November 16, 2010

Nuclear Watch New Mexico (NWNM) respectfully submits these comments on the needed scope of the *Supplemental Environmental Impact Statement for the Nuclear Facility Portion of the Chemistry and Metallurgy Research Building Replacement Project at Los Alamos National Laboratory (LANL), Los Alamos, New Mexico* (hereinafter "CMRR-NF SEIS"). We would appreciate their serious consideration by the National Nuclear Security Administration (NNSA) and look forward to the agency's comprehensive response.

**Figure 1. CMR Facility with inferred location of fault.**

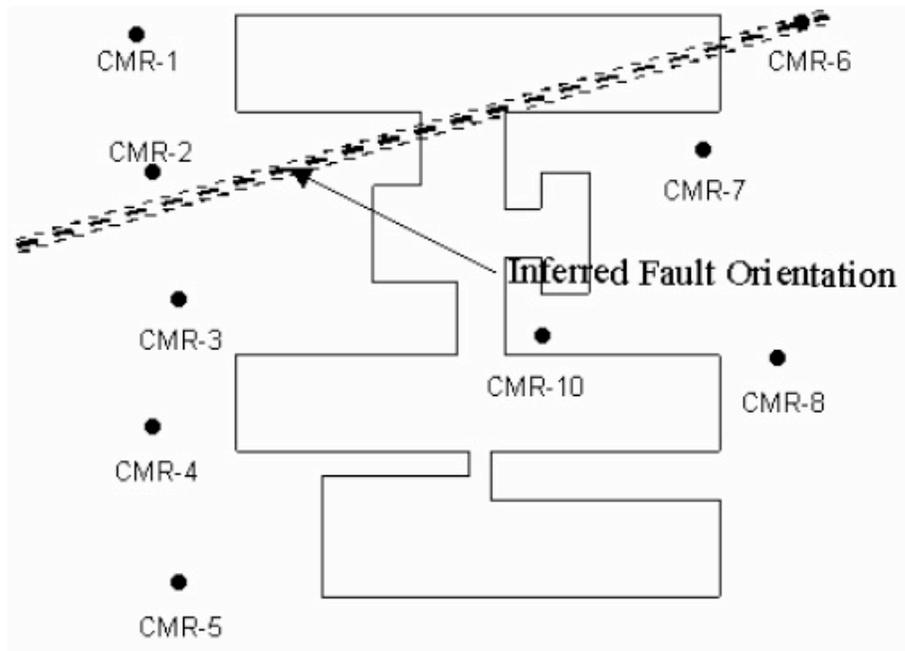
Steep topography on the Pajarito fault made field measurements difficult and the Rendija Canyon and Guaje Mountain faults have not been fully characterized.

- Rendija and Guaje faults must be mapped.
- The inferred fault at TA-3 must be mapped.
  - Where's the trench across the inferred fault at CMR?
